**Title:** Permit 24-053: Walser Kia

**Recommendation:**

Approval of MCWD permit application on the following conditions:

Re: MCWD Permit Application #24-053 – Walser Kia  
Revised Exception Request  
File 0036502.00

**SEEDING PLAN**

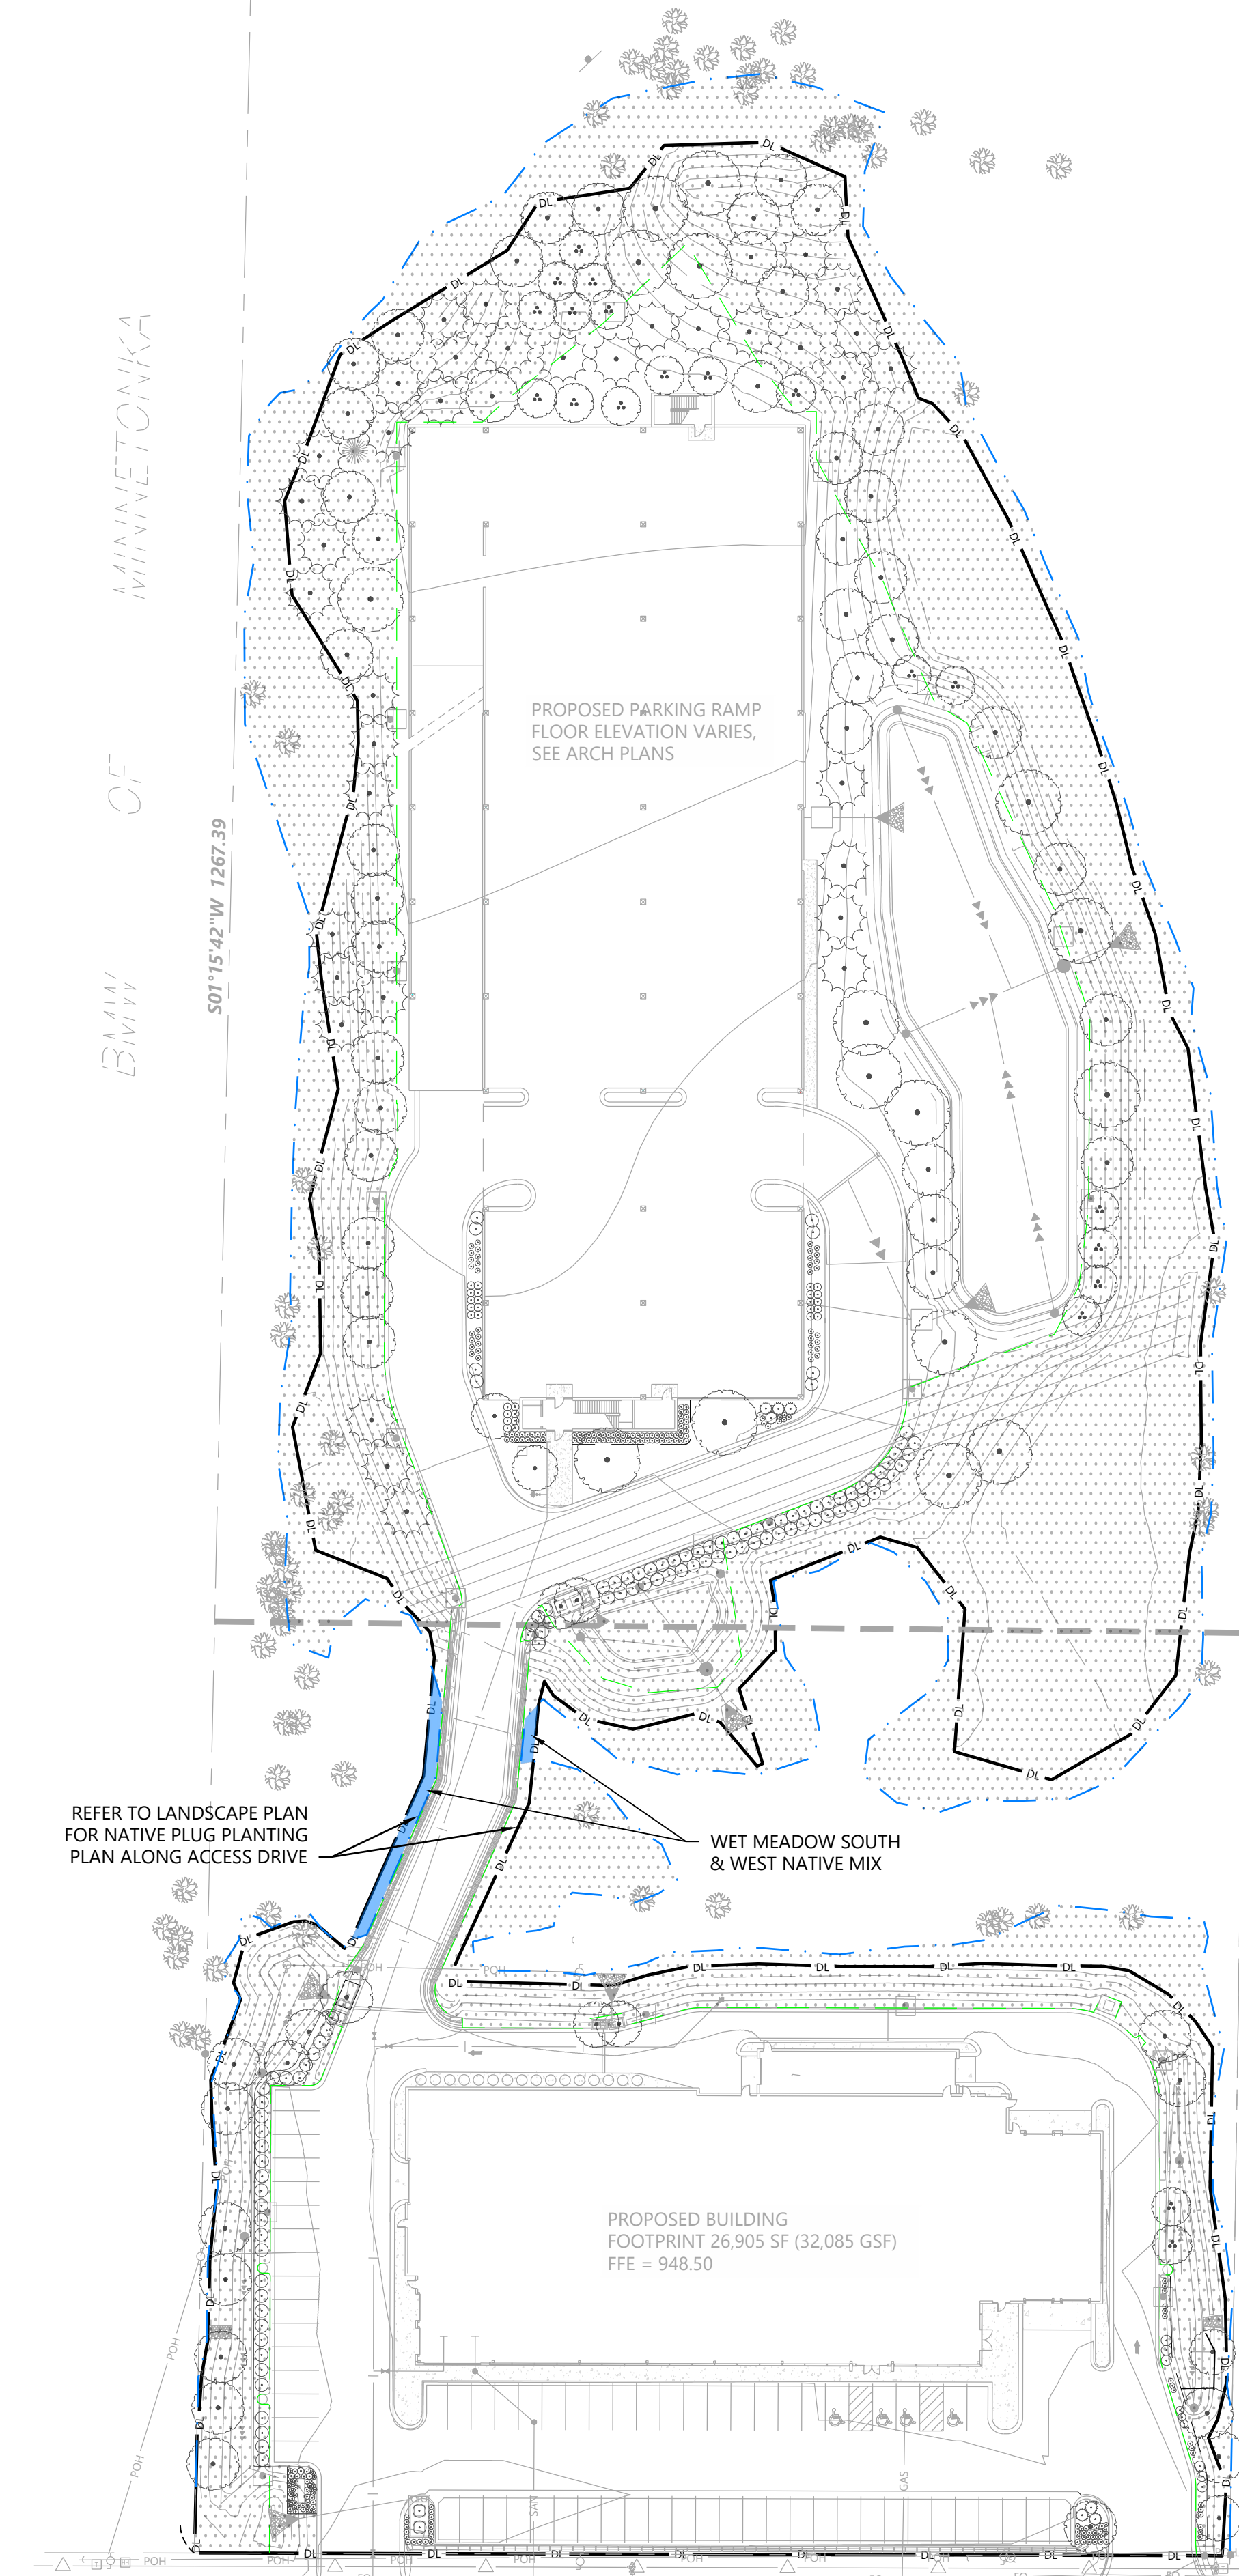
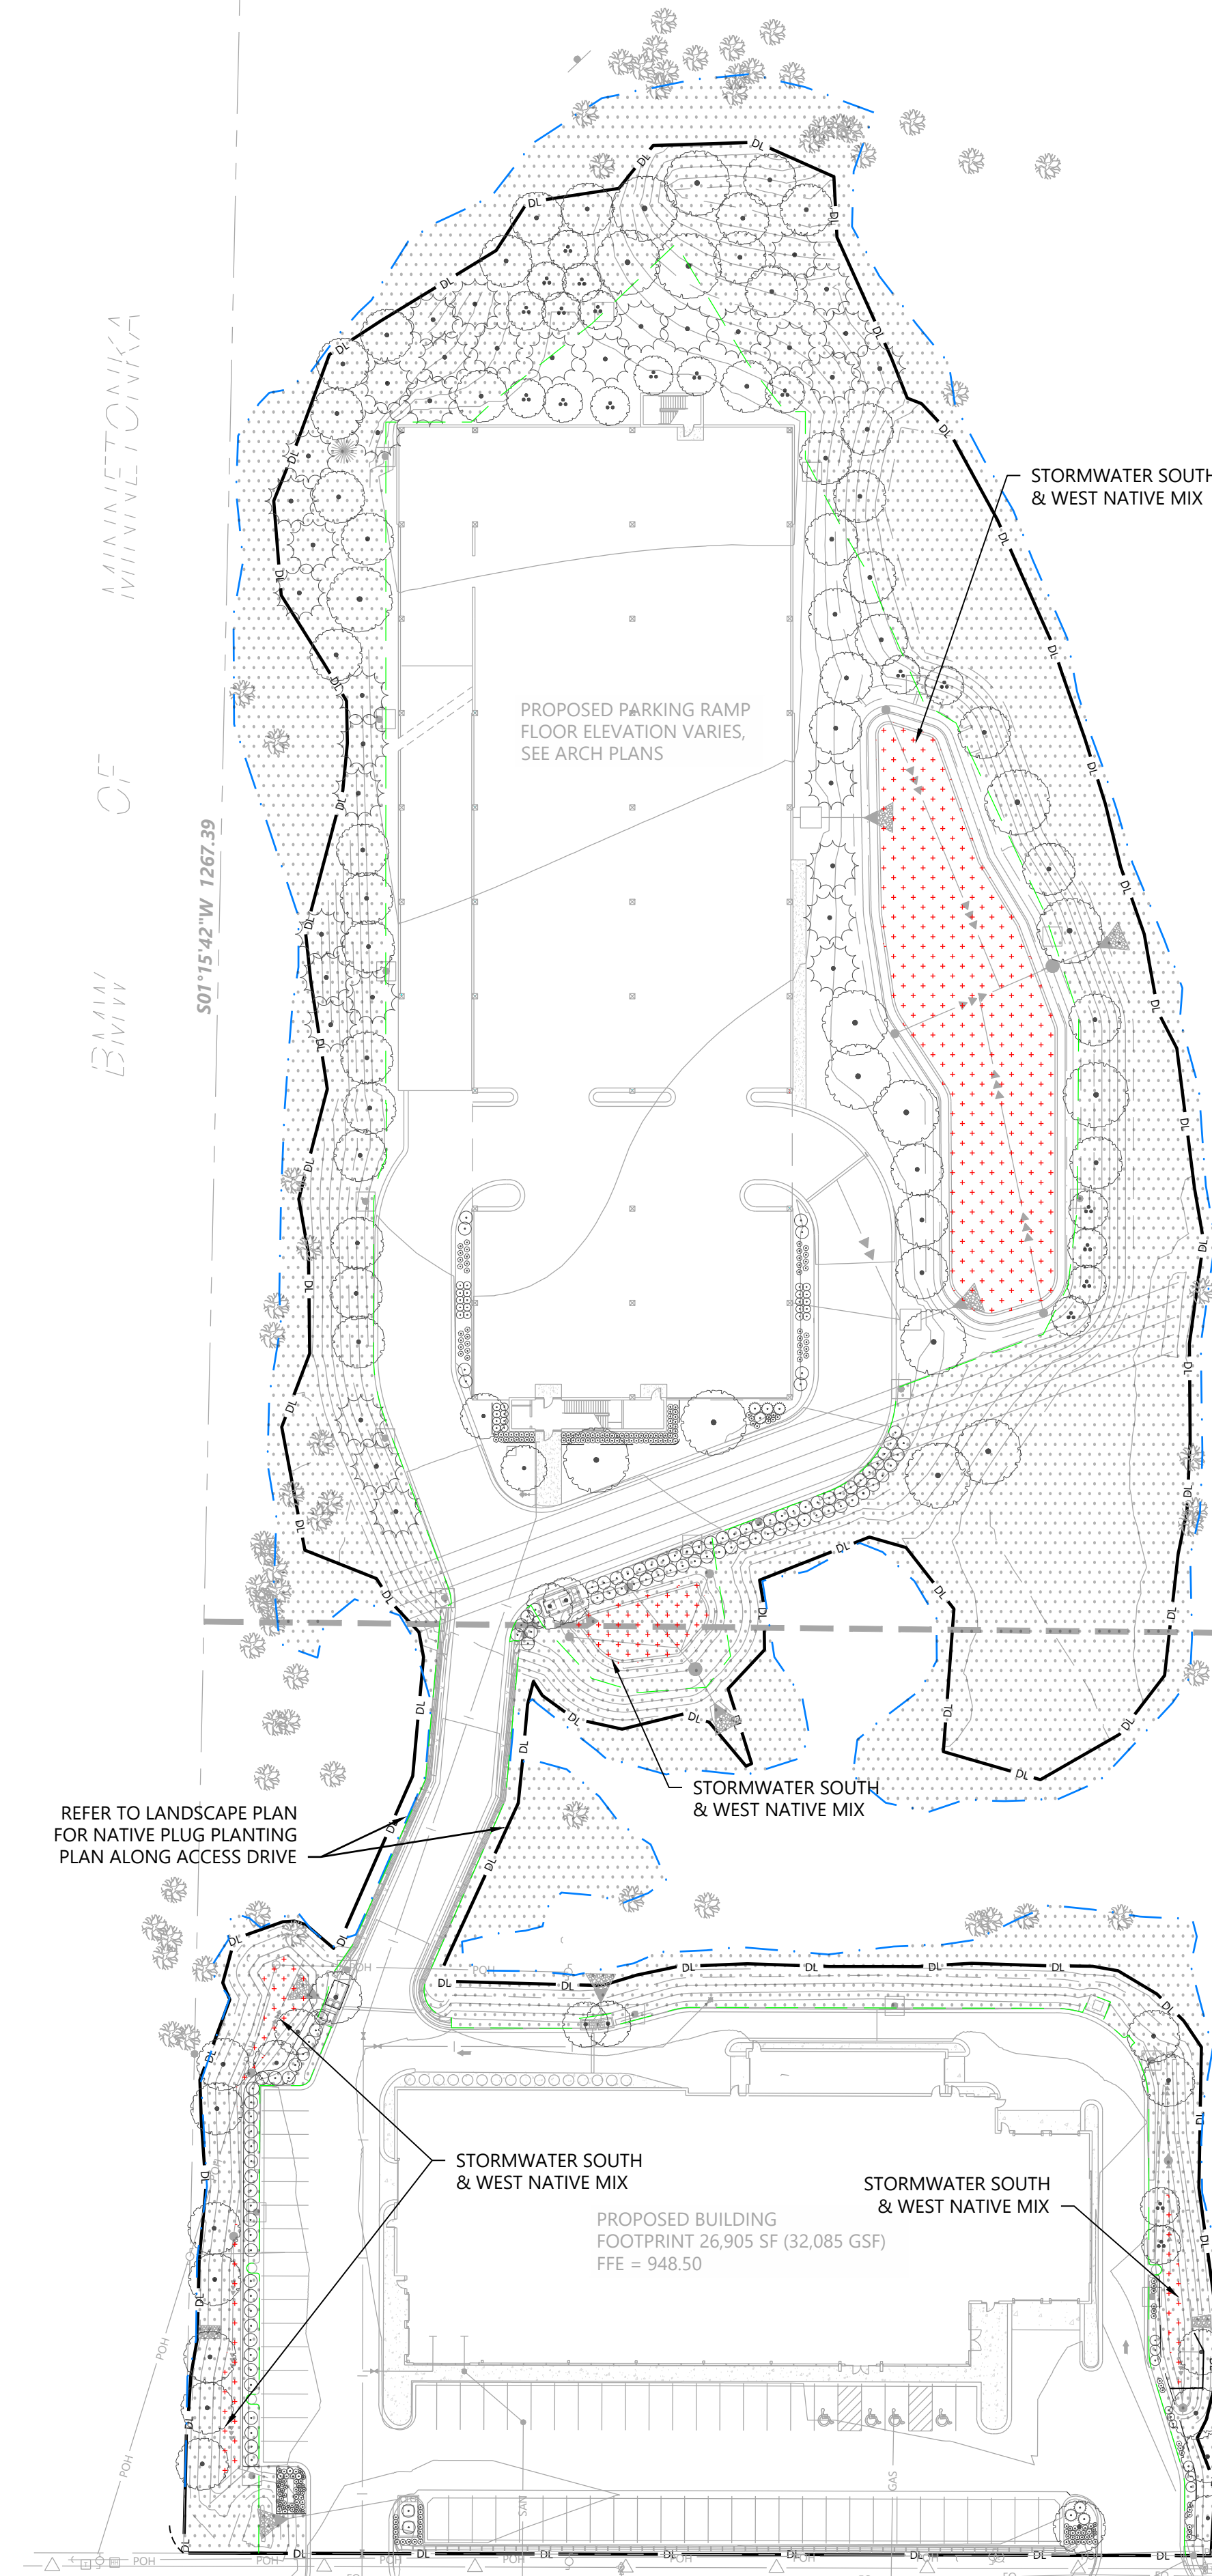
The submitted enhanced wetland buffer planting plan utilizes a Mesic Prairie seed mix (MNDOT Mix 35-641) which will be protected by hydro-mulching or erosion control blanket. In terms of an enhanced planting plan, the Applicant is proposing to go beyond the minimum requirement to re-seed and stabilize the wetland buffer, by installing native trees and shrubs throughout the buffer. These shrubs and trees bring vertical structure, songbird nesting, terrestrial habitat, and pollinator habitat.

On this basis, staff finds that the proposed planting plan will increase the volume and diversity of plant composition within the wetland buffer, beyond that which would be achieved through a standard seeding plan required under the rule.
